City of Santa Fe, New Mexico

memo

2025-011325-HDRB, 119 Camino Santiago, Downtown & Eastside Historic District, Contributing, John Padilla, agent for Dominic Serna, owner, proposes to replace windows and doors, construct a 5' yard wall with gate and a 6' coyote fence, infill two doors, construct an enclosure, reconstruct the portal, roof, and stucco, Exceptions are requested to 14-5.2(D)(5)(a)(i) for replacing historic windows and doors, 14-5.2(D)(5)(b) for altering the portal of a primary facade, installing a fence and gate on a primary facade, and 14-5.2(D)(2)(d) for the enclosure under the portal.

Figure 3: Façade diagram for 119 Camino Santiago

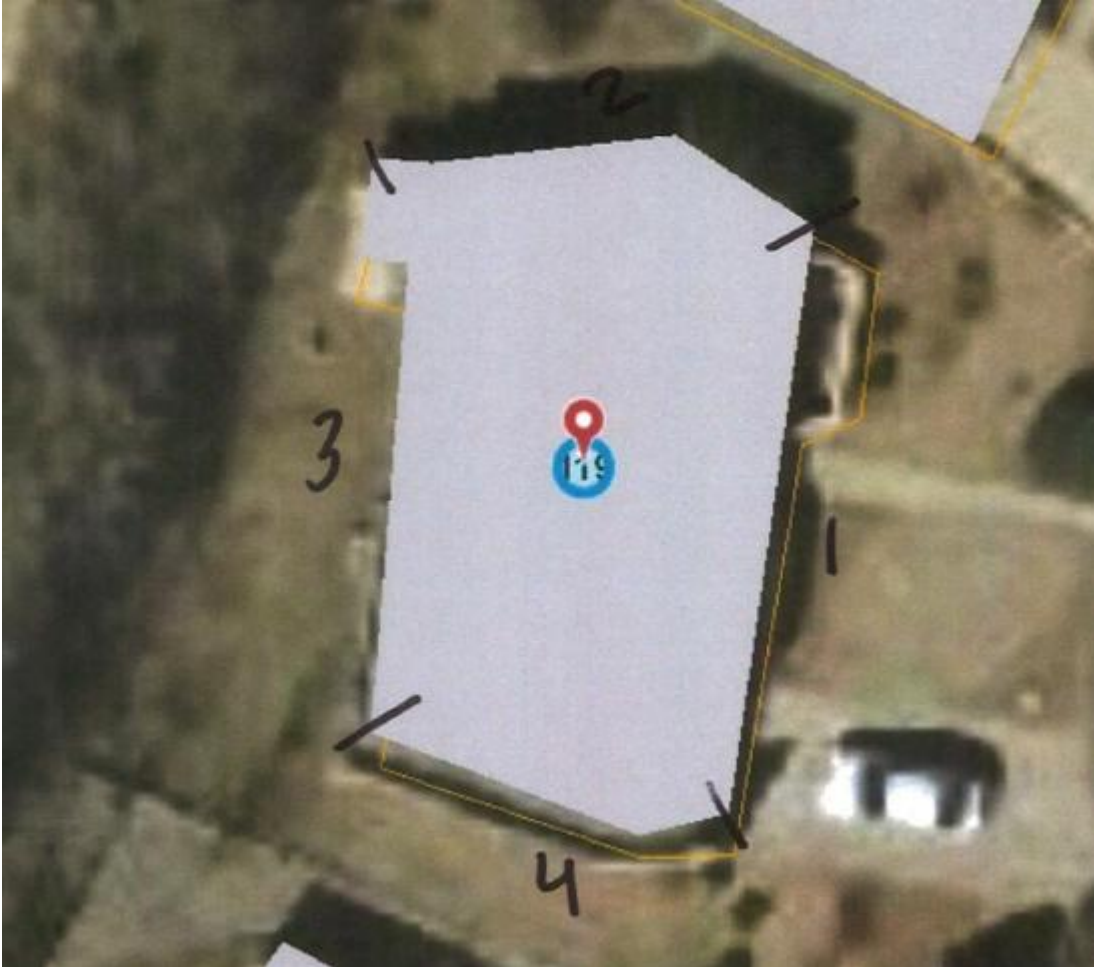
The residence at 119 Camino Santiago is designated as contributing to the Downtown and Eastside Historic District with the east (1) and south (4) facades as primary because the structure is a good example of Mid-Century Modern Santa Fe Style (low projecting roofline and south fin wall as character defining) and because of its association with Plaza del Monte, a master planned community by architects Clark and Register. Since the HDRB did not make any exclusions to the east primary facade, staff interprets the primary facade to include the south, west, and north interior walls of the carport in addition to the east facade of the residence and the portal that runs the full length of the east elevation.

All structures in Plaza del Monte were assigned statuses under cases H-17-098A and H-19-019 in 2018 and 2019. In 2019, under case H-19-019, the residence at 119 Camino Santiago was designated as contributing with the east (1) and south (4) facades as primary because the structure is a good example of Mid-Century Modern Santa Fe Style (low projecting roofline and south fin wall as character defining) and because of its association with Plaza del Monte, a master planned community by architects Clark and Register. The board specifically stated the wall in front of the entry is part of the façade and is significant in design, and the low projecting viga element is primary.
